Access Compliance Report

Public Rights-of-Way

(Curb Ramps)

Intersection ID: 18778	Main Street: INDEPENDENCE_BV	Cross Street: N/A	Location: W
ADA ID: E6F7376F309E	Ramp Type: Perp	Initial Pass/Fail: Fail	Overall Compliance: No
Severity Score: 12.5			
Codes/Mitigation Info/Possible Solution		Field Measurements/Component Compliance

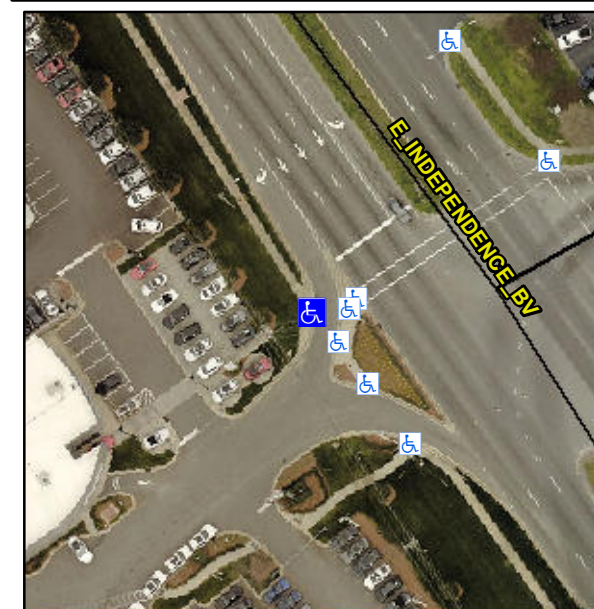
Not Found, R304.2.2

Compliance	Description	Data	Compliance	Description	Data
N/A	Ramp Length (in)	31.0	No	Ramp Slope (%)	9.5
Yes	Ramp Width (in)	48.0	Yes	Ramp XSlope (%)	0.4
N/A	Flare Type LT	N/A	N/A	Flare Type RT	N/A
N/A	Flare Slope LT (%)	N/A	N/A	Flare Slope RT (%)	N/A
N/A	Flare Traversable LT?	N/A	N/A	Flare Traversable RT?	N/A
N/A	Landing Length (in)	N/A	N/A	DWS Provided?	N/A
N/A	Landing Width (in)	N/A	N/A	DWS Contrast?	N/A
N/A	Landing Slope (%)	N/A	N/A	DWS Length (in)	N/A
N/A	Landing X Slope (%)	N/A	N/A	DWS Full Width?	N/A
N/A	Landing Curb? (Y/N)	N/A	N/A	DWS Offset (in)	N/A
N/A	Shared Landing?	N/A			
N/A	Gutter Ponding?	N/A	N/A	Gutter Slope (%)	N/A
N/A	Gutter Lip Ht (in)	N/A	N/A	Gutter X Slope (%)	N/A
N/A	Painted X Walk1?	No	N/A	Painted X Walk2?	N/A
	X Walk 1 Direction	To SE		X Walk 2 Direction	N/A
N/A	X Walk 1 Width (in)	N/A	N/A	X Walk 2 Width (in)	N/A
	X Walk 1 Slope (%)	0.8		X Walk 2 Slope (%)	N/A
	X Walk 1 X Slope (%)	0.8		X Walk 2 X Slope (%)	N/A

Remove & Replace Entire Ramp.
